Millstone Power Station

2000 Radioactive Effluent Release Report

MAJOR

**MILLSTONE STATION
RADIOLOGICAL EFFLUENT MONITORING AND OFFSITE DOSE CALCULATION MANUAL
(REMODCM)**

FIGURE IC-2
SIMPLIFIED LIQUID EFFLUENT FLOW DIAGRAM
MILLSTONE UNIT TWO

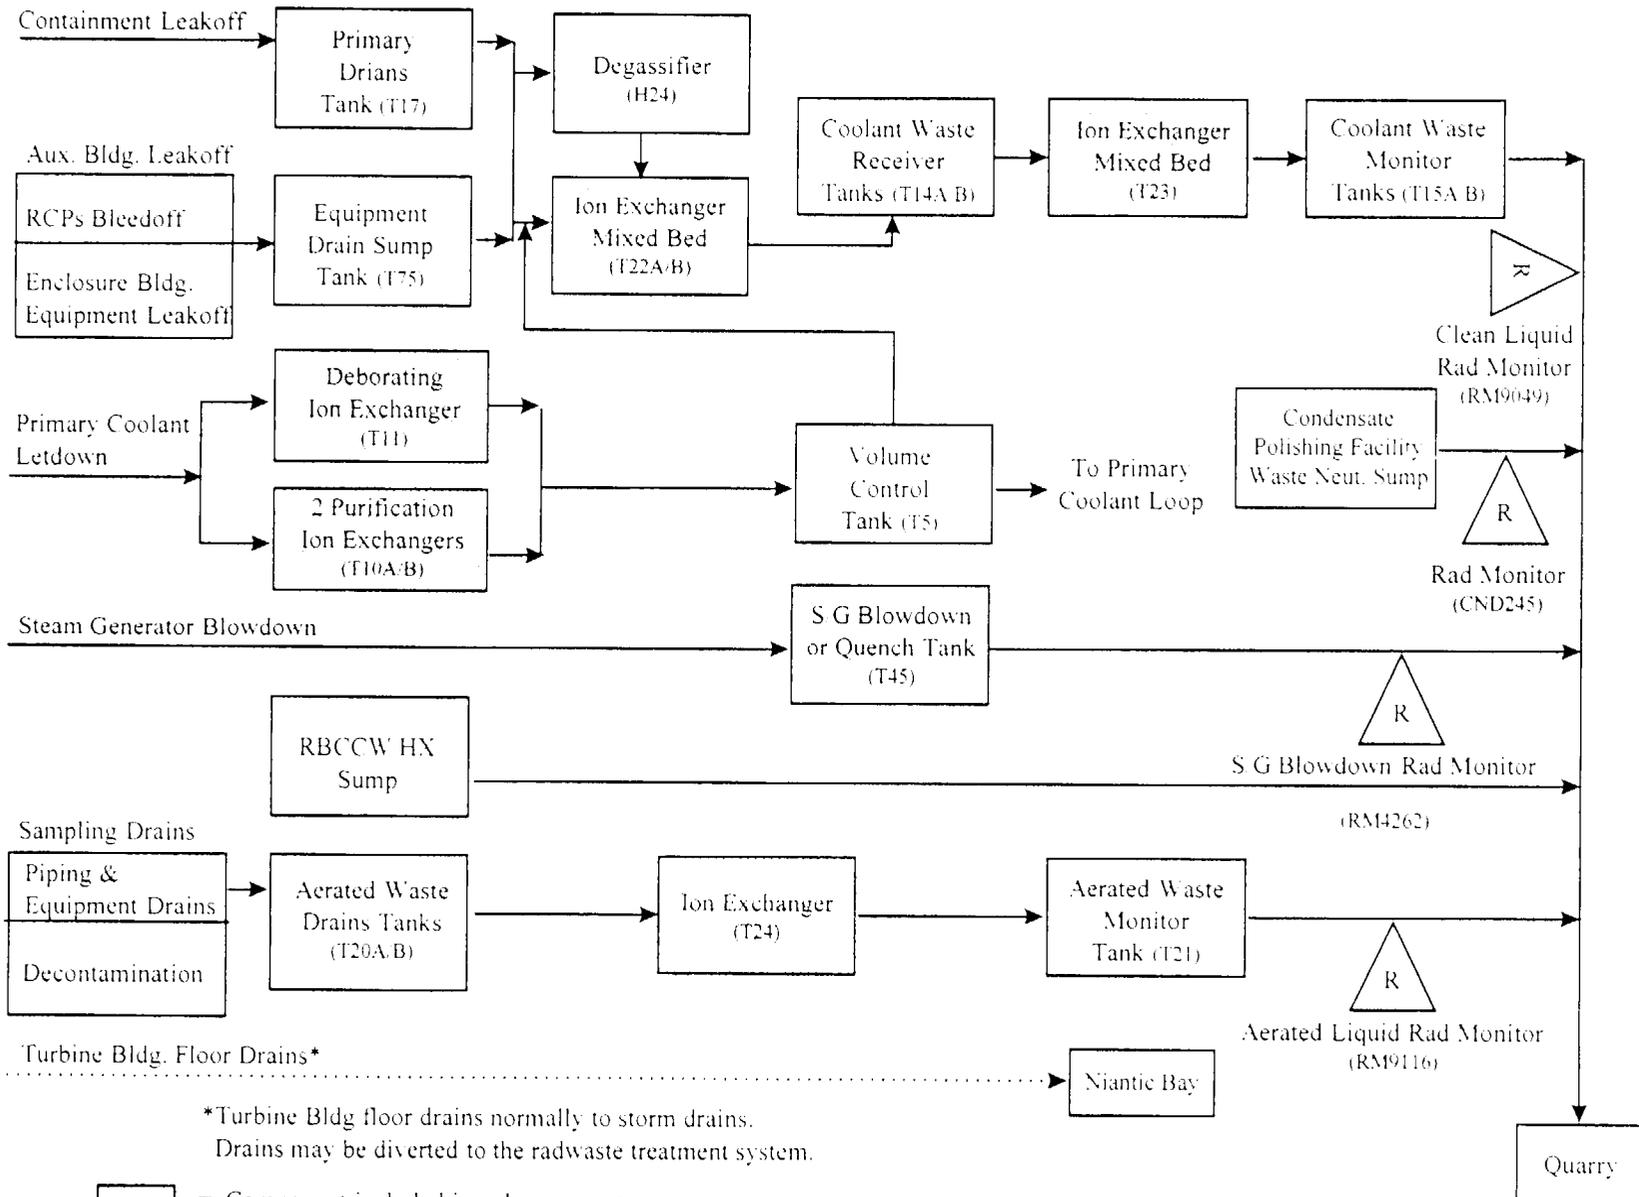
NEW

FIGURE 1D-2
SIMPLIFIED AIRBORNE EFFLUENT FLOW DIAGRAM
MILSTONE UNIT TWO

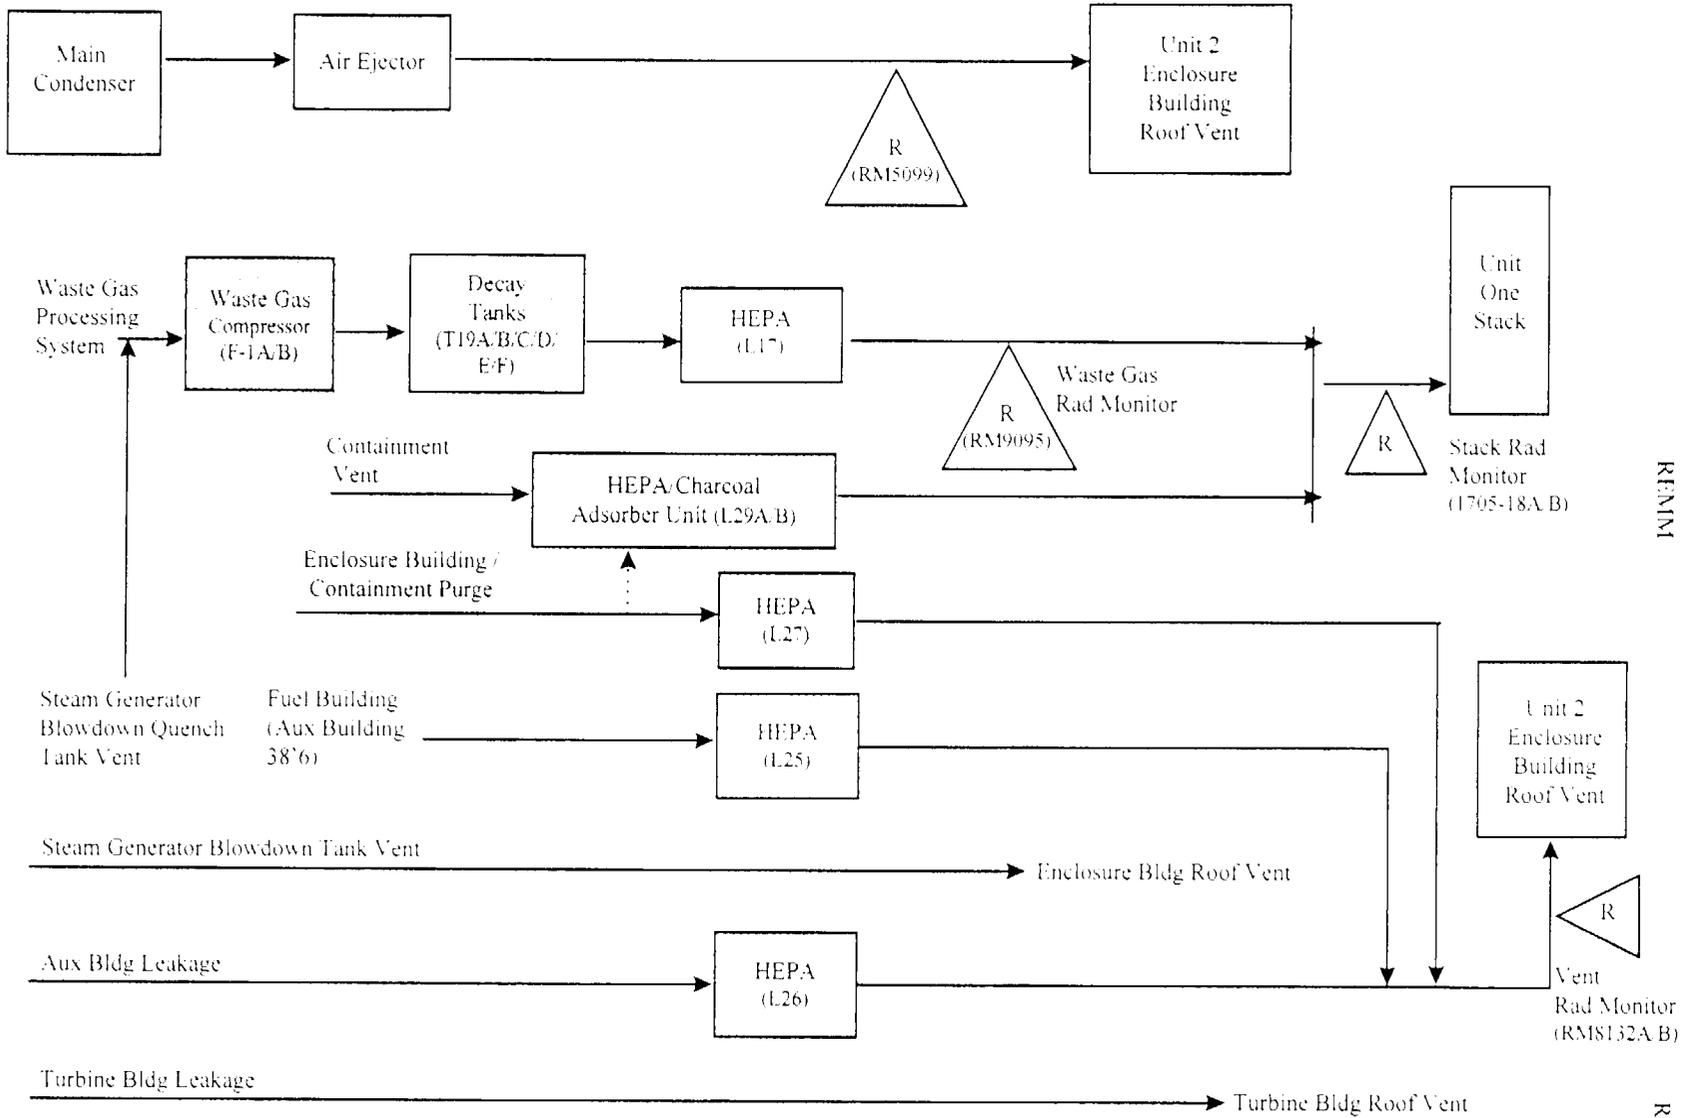
Revision 18
New
